HUMAN FACTORS ASSESSMENT: M9 ARMORED COMBAT EARTHMOVER (ACE)

REPORT DOCUMENTATION PAGE		READ INSTRUCTIONS BEFORE COMPLETING FORM
1. REPORT NUMBER ARI Research Note 88-12	2. GOVT ACCESSION NO.	3. RECIPIENT'S CATALOG NUMBER

4. TITLE (and Subtitle) Human Factors Assessment: M9 Armored Combat Earthmover (ACE)		5. TYPE OF REPORT & PERIOD COVERED Final Report February 1983 - December 1985

Figure 52. The location of the battery box below the radio box and behind the radiator grille.

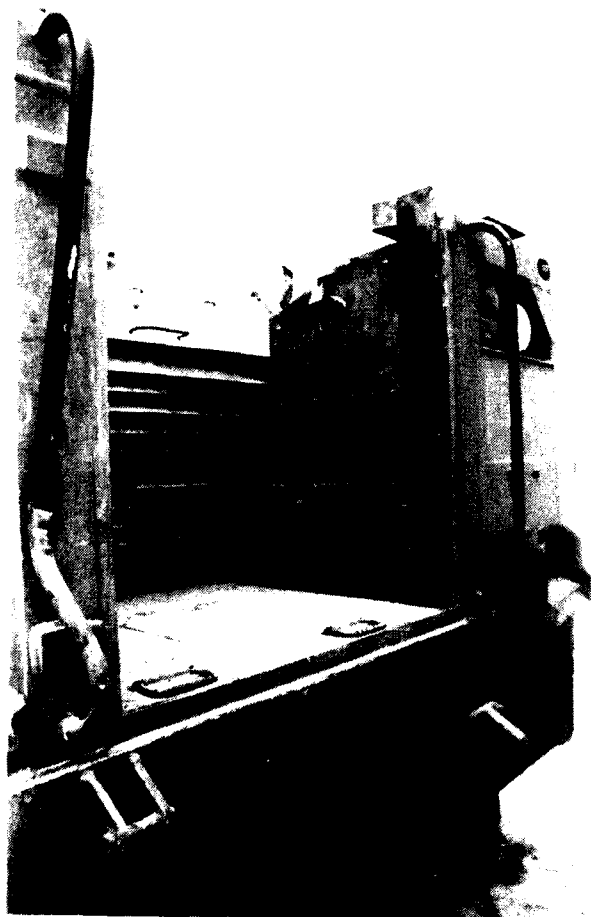
Description of the Deficiency: Figure 52 shows the battery box located beneath the radio box at the rear of the M9. Three operators and four mechanics reported that they could not see into the furthest battery ports or inspect the terminals because their view and reach were blocked by the radio box. The radio box is approximately 12 in (29 cm) above the batteries. The limited space also makes removing and replacing the batteries difficult.

Implications for the Mechanic, the Operator, and the Equipment: The battery fluid was frequently low due to the high temperatures created by the muffler and the radiator. The low fluid levels were often not detected during daily PMCS maintenance checks. Damage to the batteries may result.

Potential Solutions: The radio and batteries may need to be relocated. High temperatures generated by the muffler and radiator damaged the equipment during the test. If the hatch and driver's station are reconfigured, the radio might be placed in the driver's station and the battery box might be located above the fuel tank.

Figure 53. A mechanic reaching between the roadwheels to position the dog bone jack.

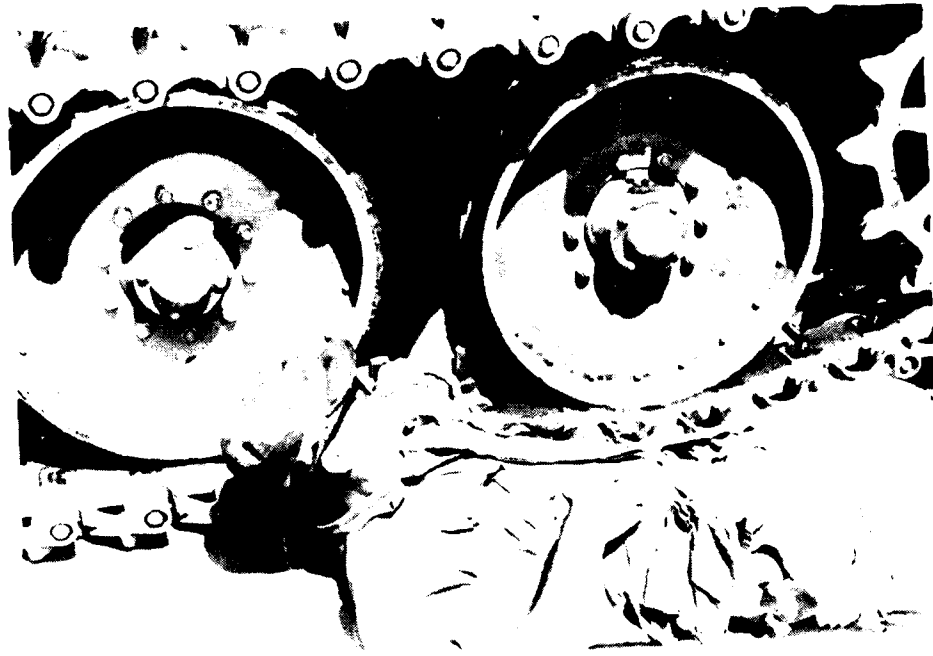
Description of the Safety Hazard: Figure 53 shows a mechanic reaching into the roadwheels in order to hold a dog bone jack in place between the upper and lower portions of the track. Figure 54 shows the dog bone jack.

1. Use the hydraulic jack only on hard paved surfaces.
2. Modify the dog bone jack to make it self-standing during positioning of the vehicle. This might be done by adding a hinged bipod to one side of the jack. The bipod would angle outward from the jack and wedge into the ground, creating a tripod of the jack.
